RESPONSE TO SUBMISSIONS

Section 75W Modification Application
Moolarben Coal Project – Stage 1
(05_0117 MOD 7)
Northern Borefield

June 2010

Figure 1 General borefield layout

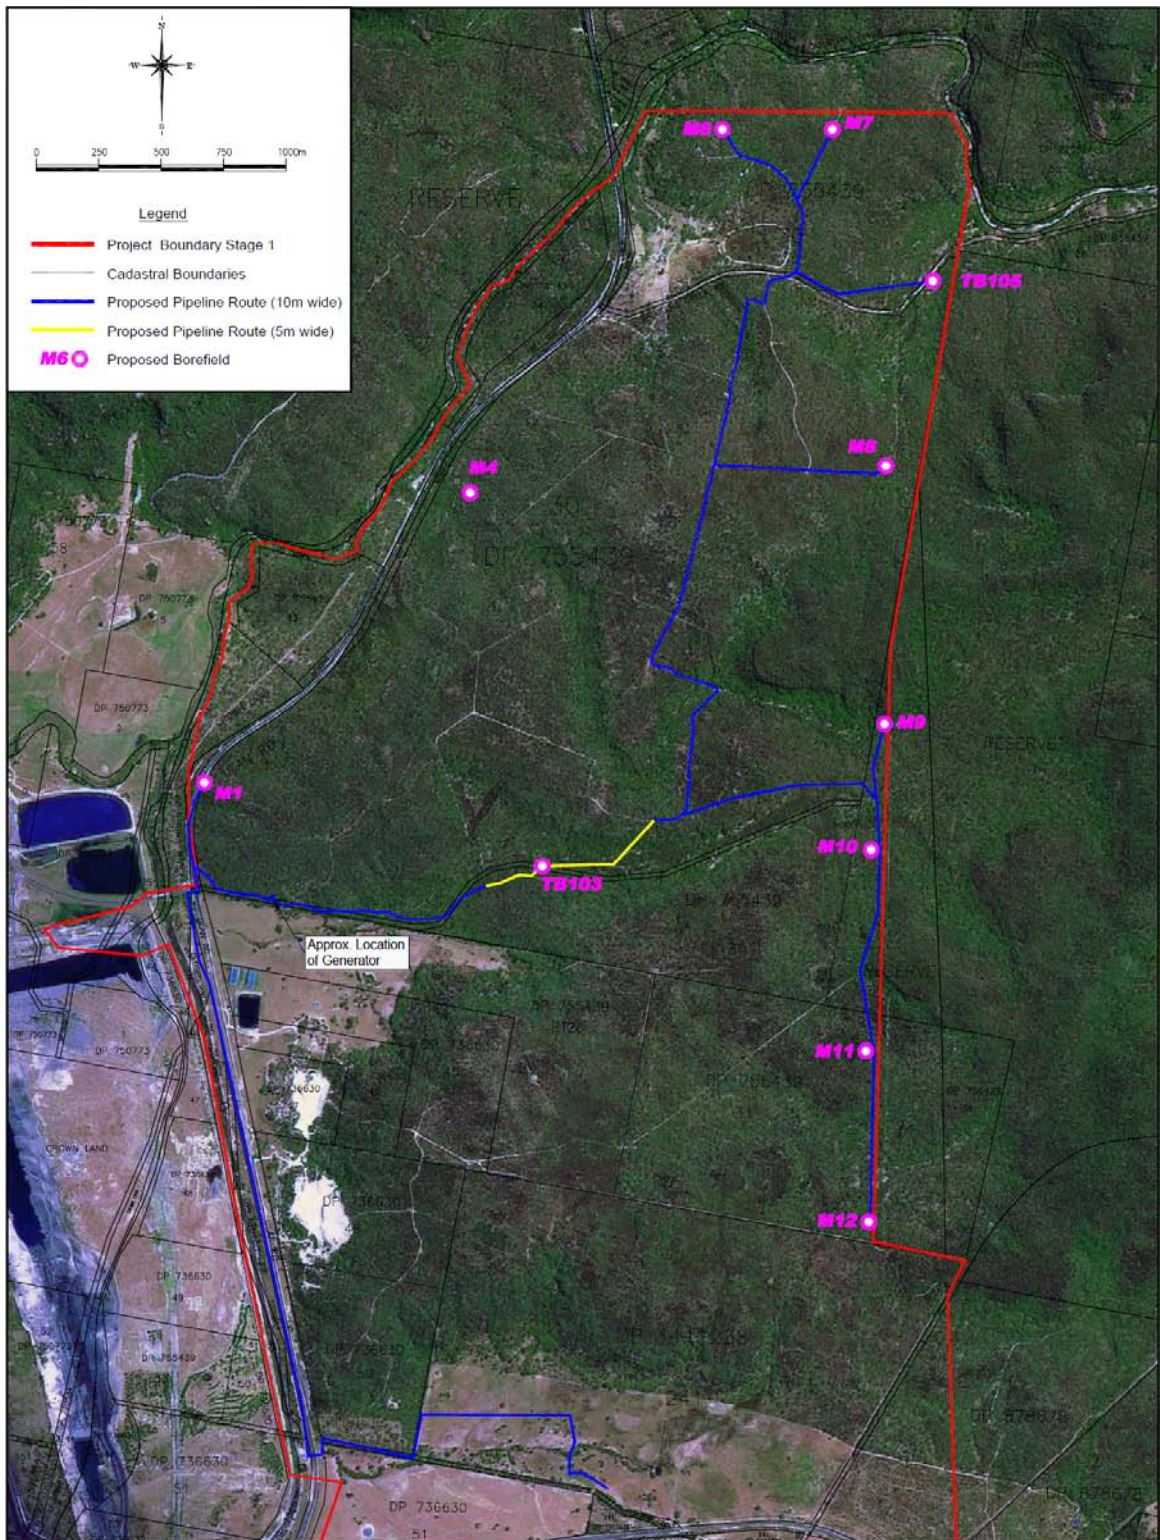
After careful review of the issues raised in submissions on the modification application, MCM has revised the borefield layout to reduce the extent of impacts associated with the construction and operation of the borefield. These changes include:

- Burying the pipelines and power supply cabling in a common trench.
- Reducing the width of the infrastructure easement from 20 m to 10 m.
- Removing above ground storage tanks.
- Removing transfer pumps.
- Reducing cleared areas around bore head works.
- Using a single generator to provide power to the borefield.
- Adjusting the pipeline route to further reduce clearing and ground disturbance impacts.

Pipelines and powerlines will be buried in a common trench up to 1 m wide, within a 10 m wide infrastructure easement. The easement will generally be established along existing cleared or disturbed areas (generally comprising unsealed roads and 4WD tracks) to minimise vegetation clearing and land disturbance. The general layout of the borefield is shown in Figure 1.

A 2 km segment of the pipeline route in the vicinity of bore TB103 has now been replaced with a more direct 800 m long segment. The infrastructure easement along this re-aligned section will be restricted to no more than 5 m in width, sufficient to enable the construction of the trench and to provide adequate erosion and sediment control. The final route of this pipeline segment will be positioned to avoid clearing mature trees. Long-term vehicle access to TB103 will be provided by existing tracks.

Figure 2 Pipeline network schematic layout

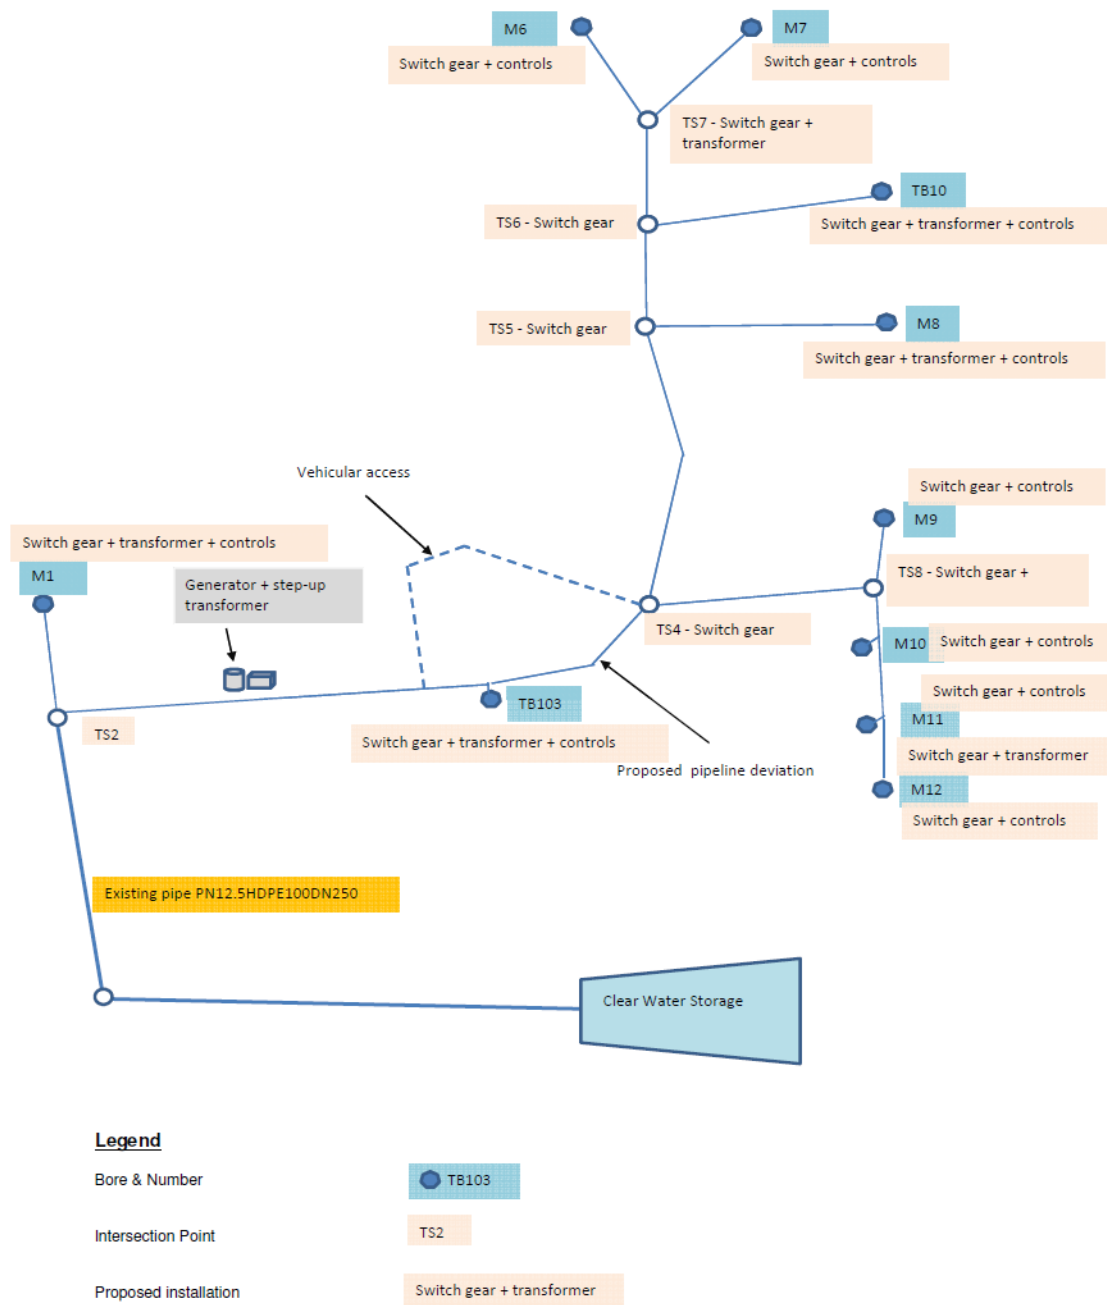
About 10.4 km of pipeline (previously 12 km) will be established to transfer extracted groundwater directly from the bores to a water storage dam within the mine infrastructure area (Figure 1 and Figure 2). The pipeline will be constructed of high density polyethylene (HDPE) piping (90 to 250 mm in diameter), typical of that used for water supply and conveyance at other NSW coal mines.

Power will be delivered to each bore and pipeline junction switch gear via a high voltage cable, which will be buried within the pipeline trench. About six transformers will be located at strategic bore and pipeline junction locations. The indicative location for transformers is shown in Figure 2

Figure 3 Indicative sections – infrastructure easement, bore and switch gear pads

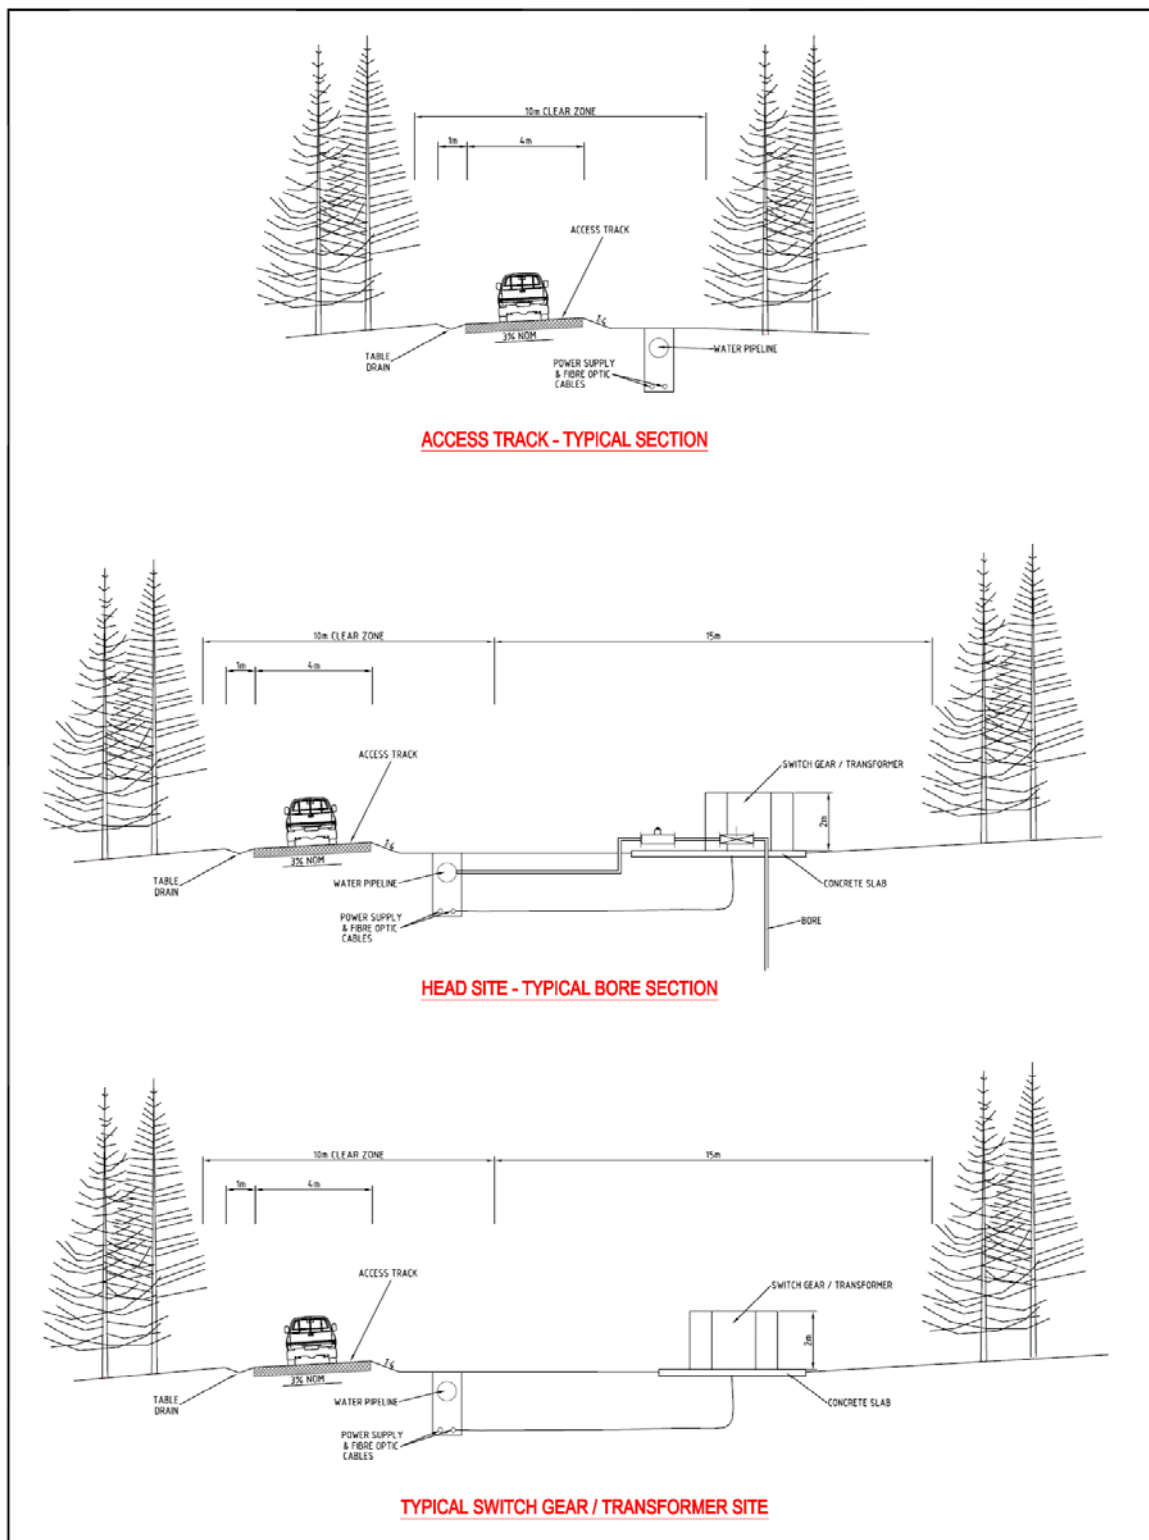
The pipeline, powerline and borefield access tracks will be established within a 10 m wide infrastructure easement (previously 20 m). The pipeline, powerline and fibre optic control cable (for pumps and switch gear) will be located in a single trench generally positioned alongside the pipeline access track. A typical configuration for the infrastructure easement is shown in Figure 3.
